**PROJECT:** 2023 CWSRF SANITARY SEWER SYSTEM REHABILITATIONS  
FOR THE WETUMPKA WATER WORKS & SEWER BOARD  
CWSRF PROJECT NO. CS010460-06  
GMC PROJECT NO. CMGM230096(2)

**RE:** **ADDENDUM #1**

# ADDENDUM NUMBER 1

**C-301**

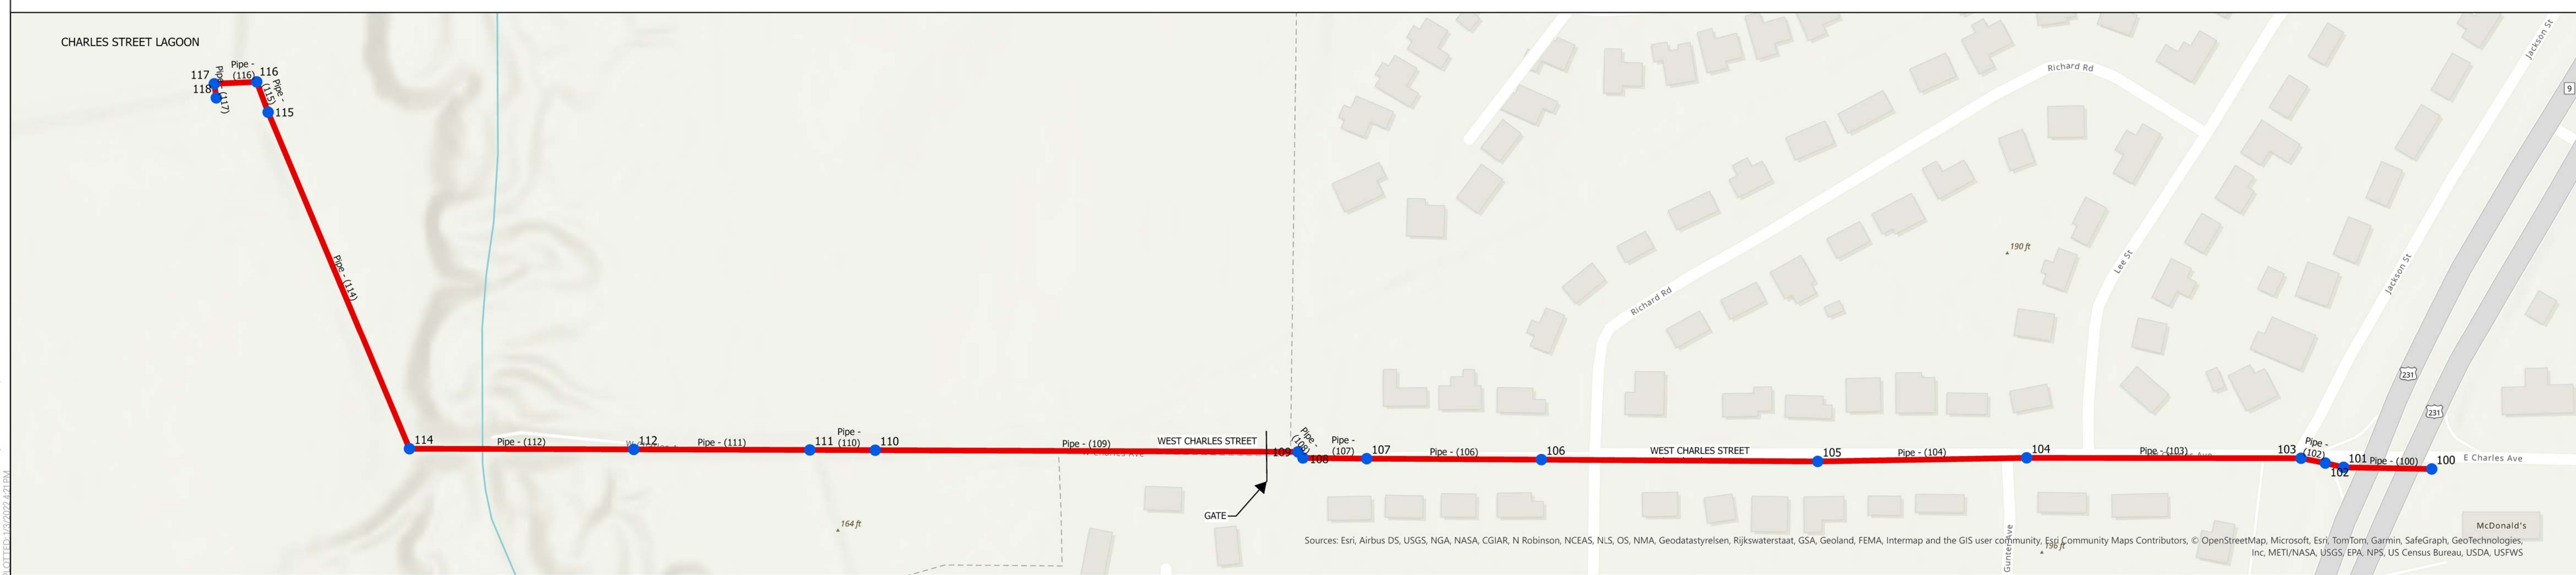
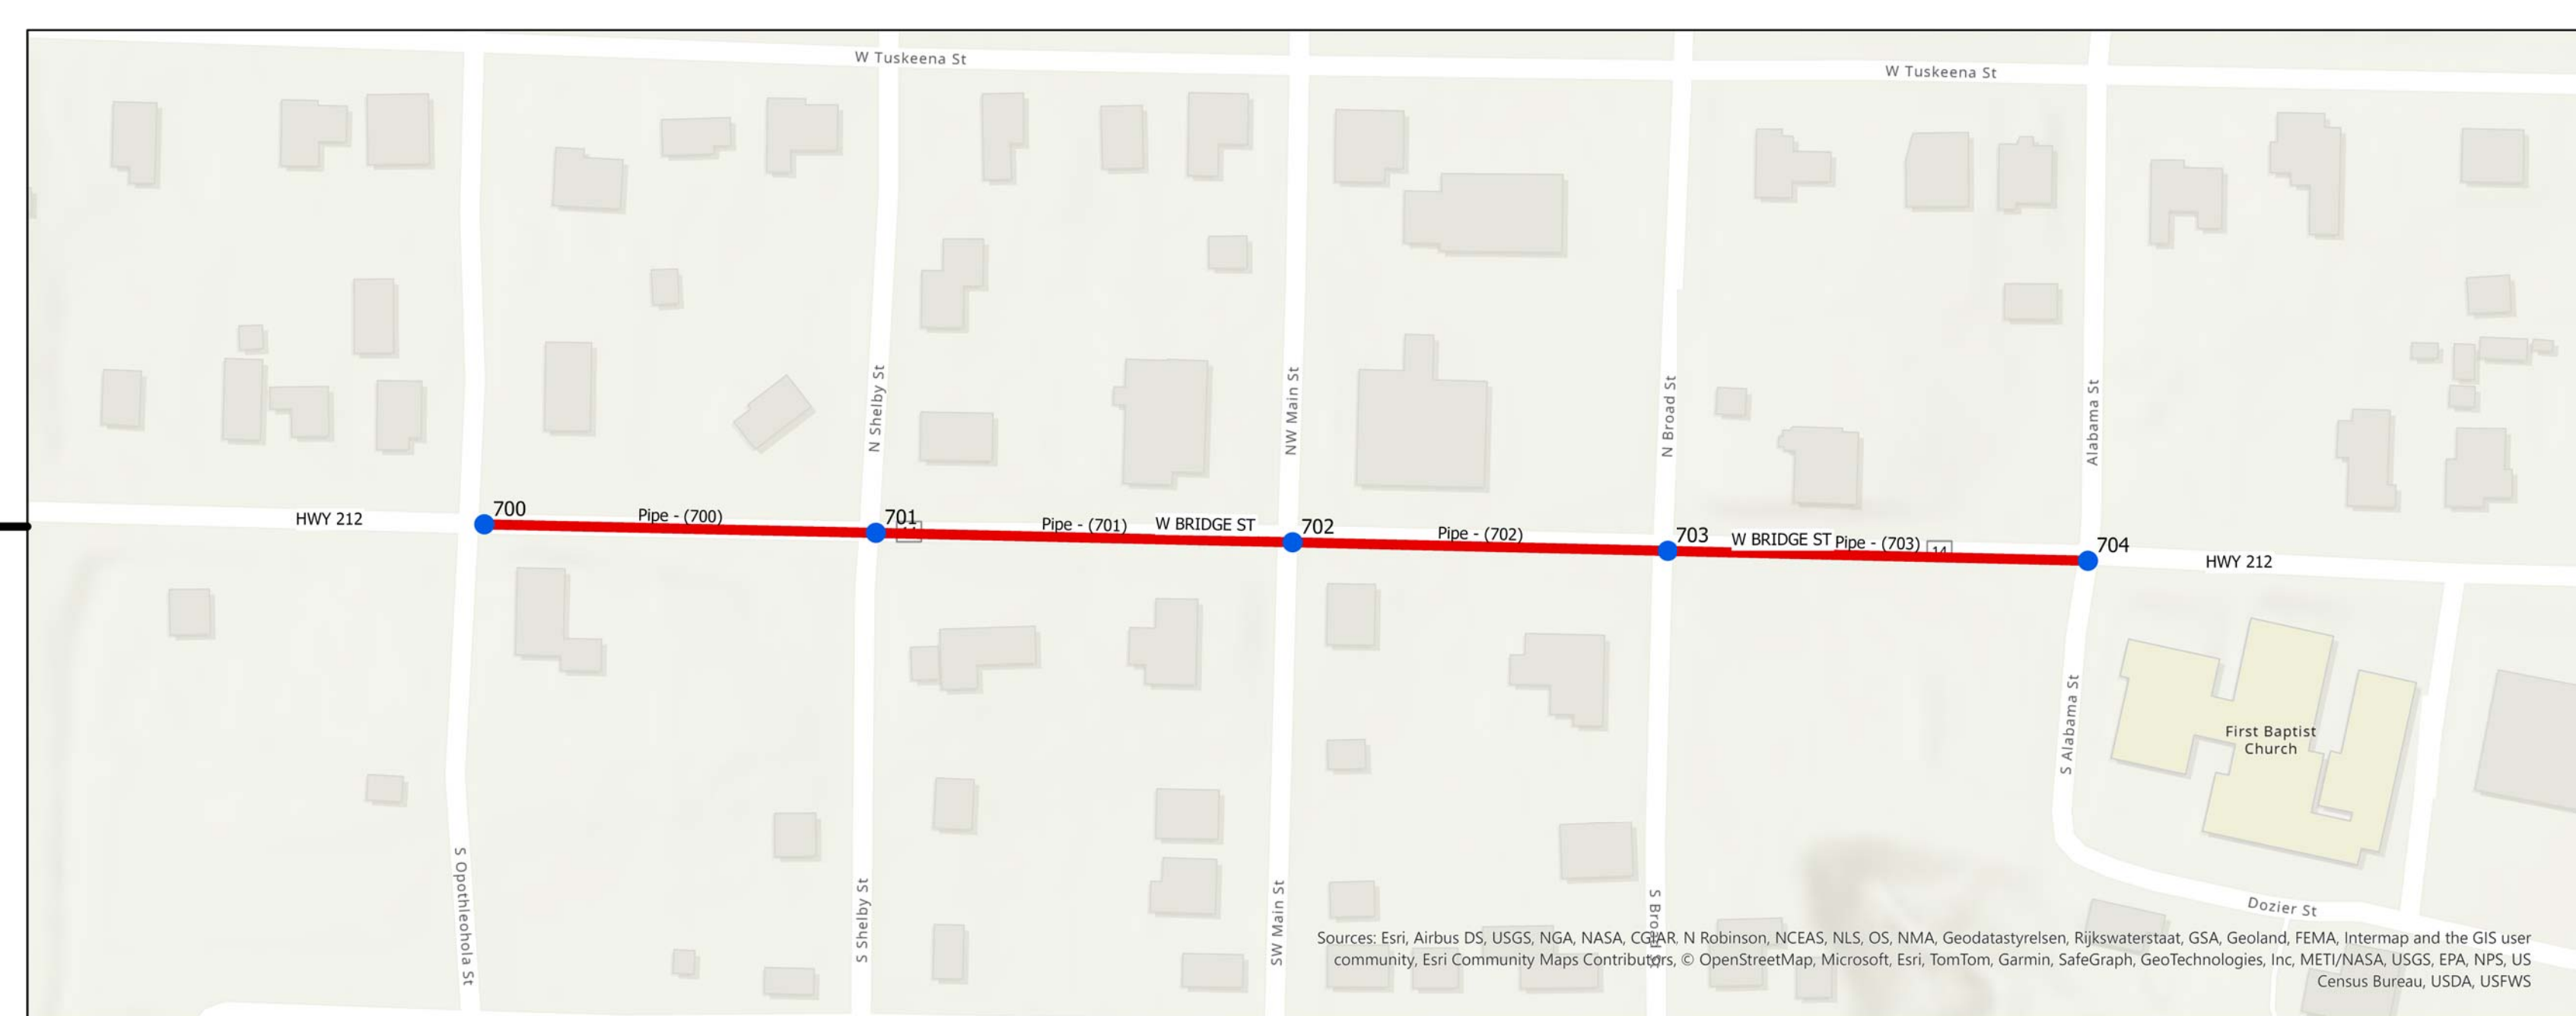
- 4.8 Question: Per the bid form, the base bid includes 6,060 LF of CIPP lining and the Alternate includes 3,489 LF total of CIPP lining. Could you please clarify which sheets/specific pipe segments are meant to be included on the base vs the alternate bid?

Answer: Plan sheet C-303 and C-301 are loosely included in Base Bid and plan sheet C-302 in the Additive Alternate. Upon review of the CCTV video by the Engineer and Owner, the contractor will be advised of the number and location of the point repairs to be made along with the line segments to receive CIPP liner no matter which plan sheet they are located on.

**DETAILS - TYPICAL REPAIR TO EXISTING SEWER**  
NOT TO SCALE

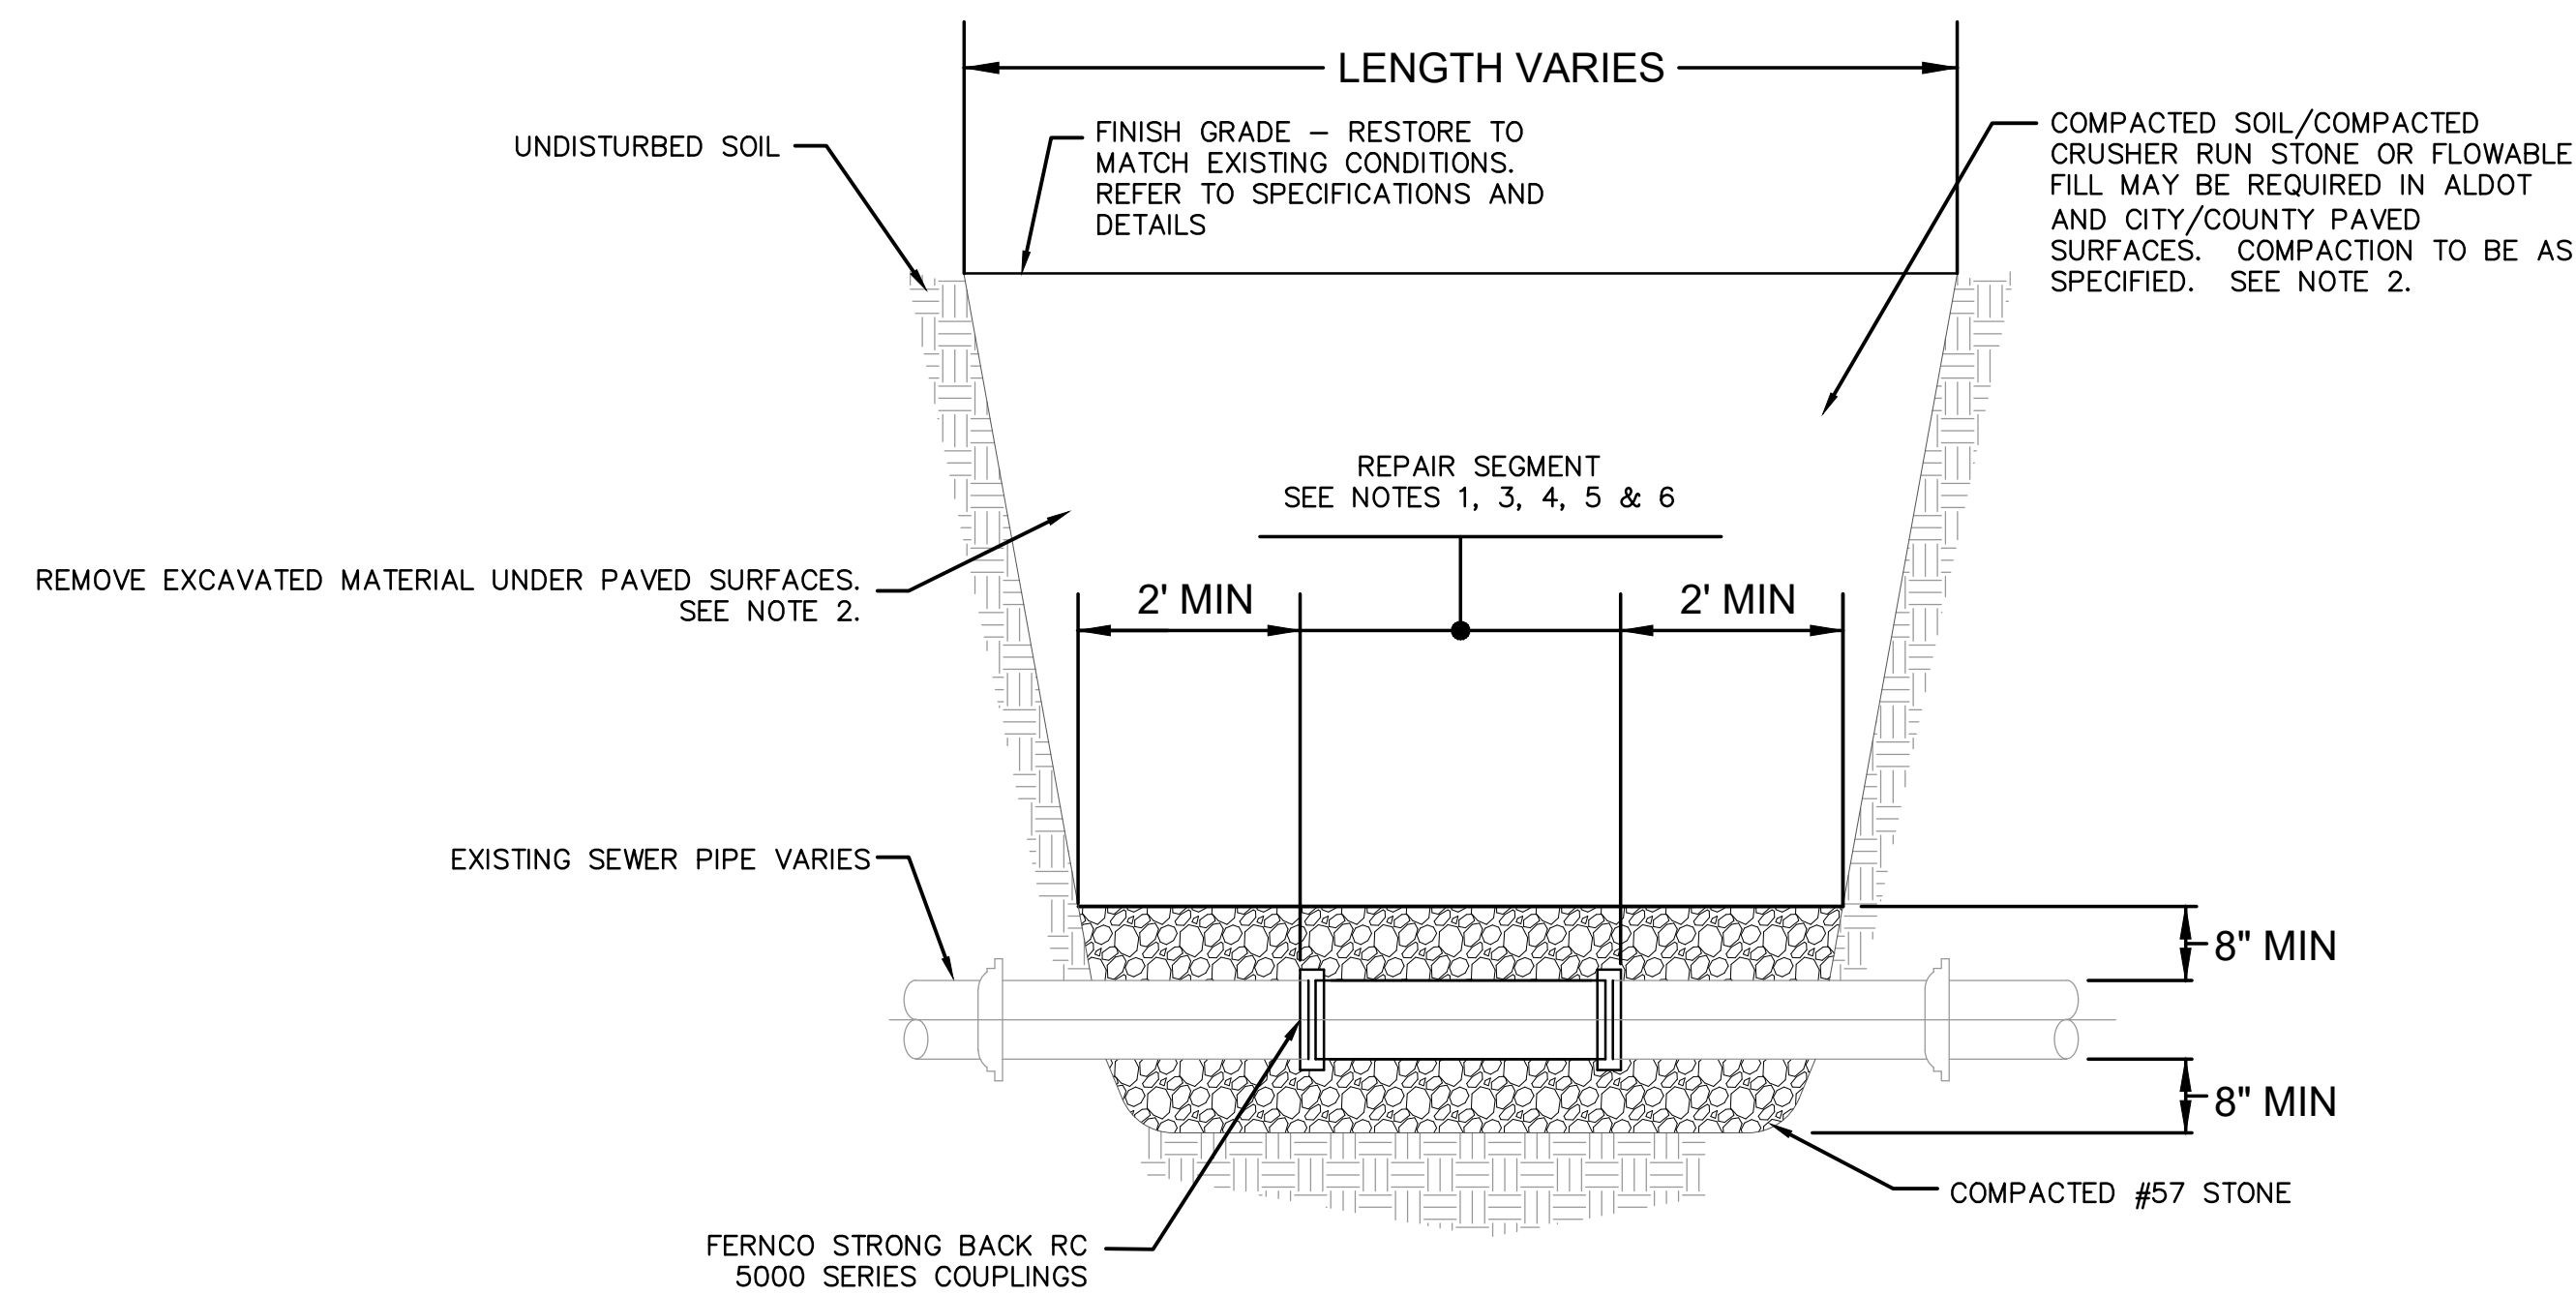
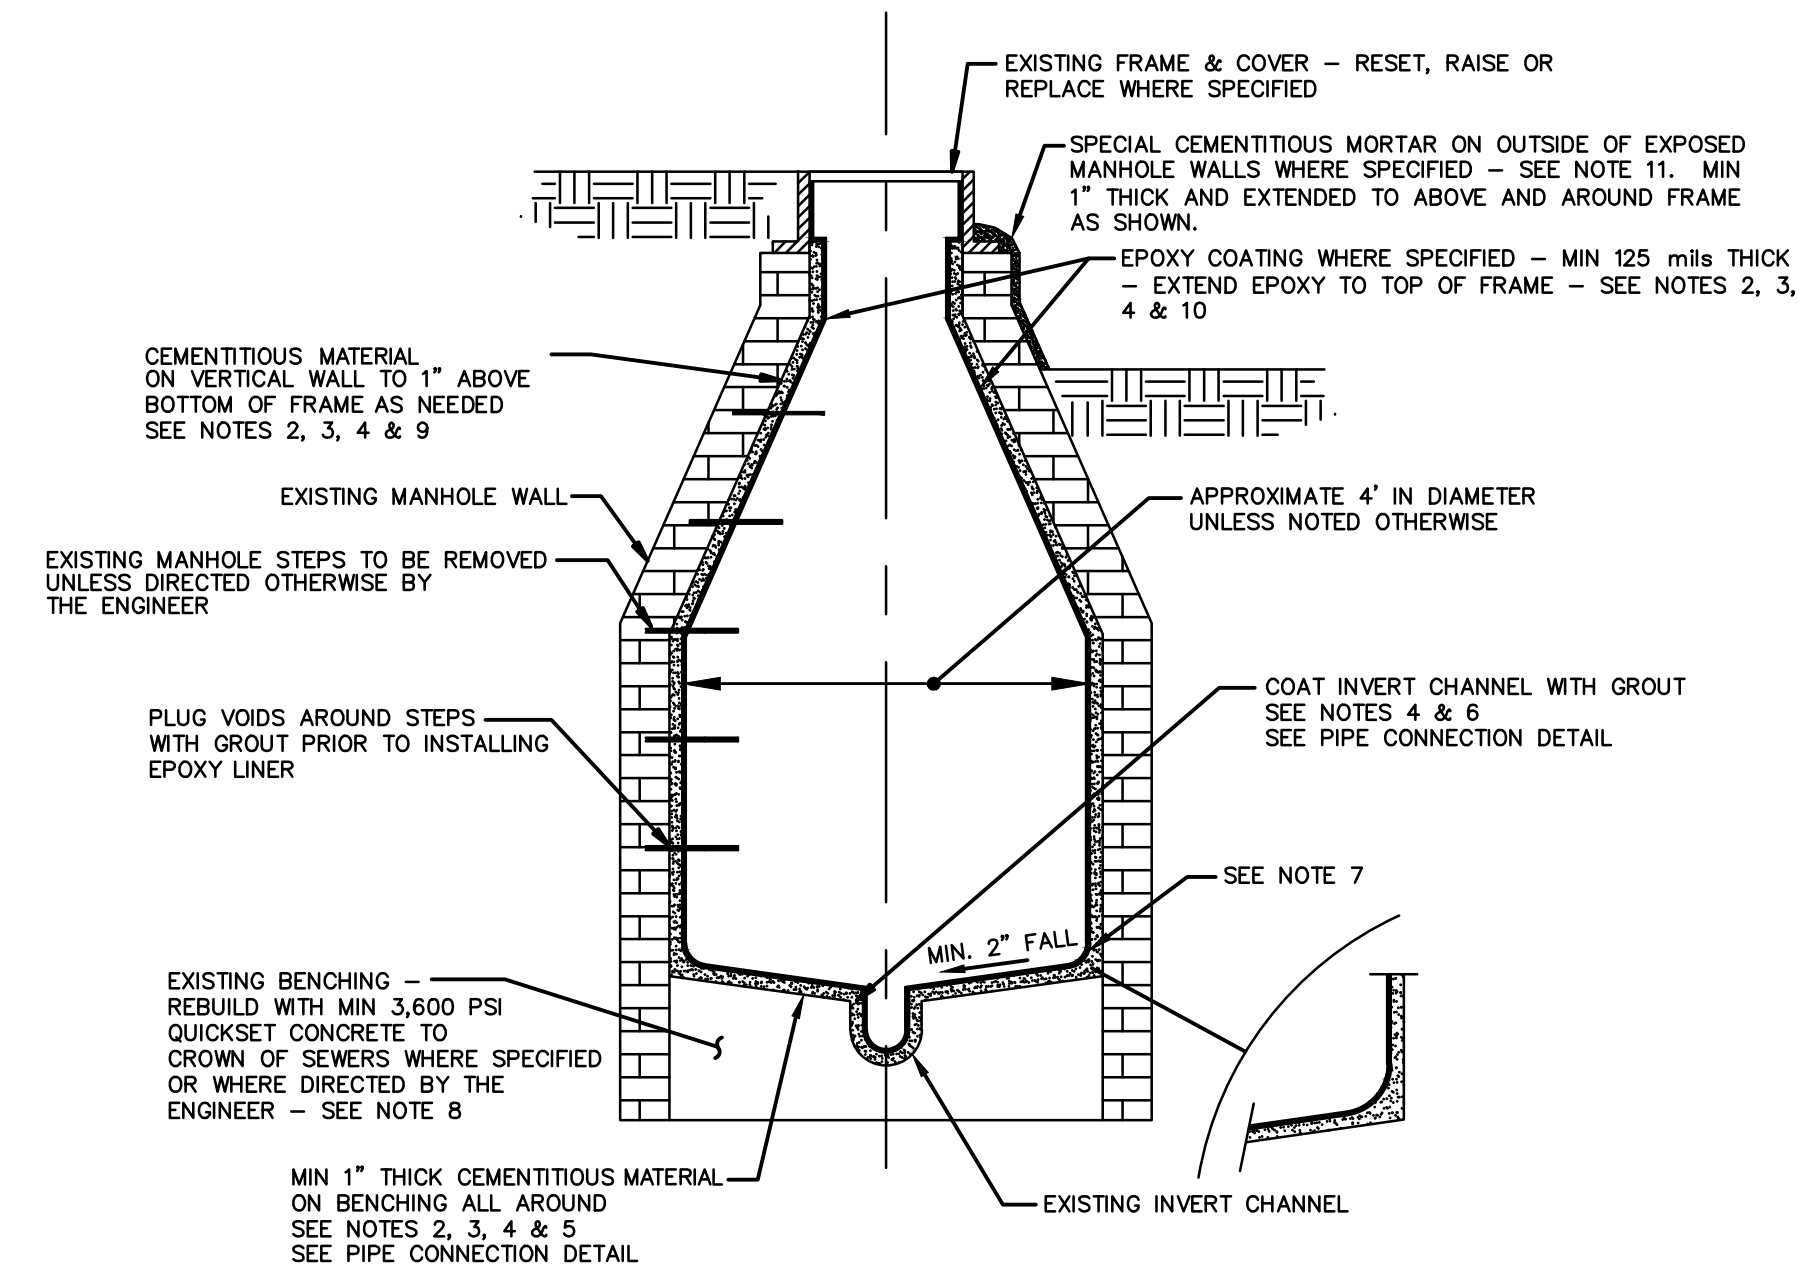
- 3.1 The contractor shall use Strongback RC 5000 couplings by Fernco, Inc. for point repair connections.
- 3.2 The existing pipe sizes identified in the plan set may vary as indicated in the bid proposal and revised Addendum No. 1 plan set. Exact sizes shall be field determined by the contractor.

- INSTALL NEW DIP SEWER AT A CONSTANT SLOPE BETWEEN THE TWO EXISTING PIPE ENDS. CONNECT THE NEW SEWER TO THE EXISTING WITH A FERNCO STRONG BACK RC 5000 SERIES COUPLINGS. REMOVE STONE BEDDING AS REQUIRED TO INSTALL PIPE AND COUPLINGS AND FILL VOIDS UNDER PIPE WITH STONE.
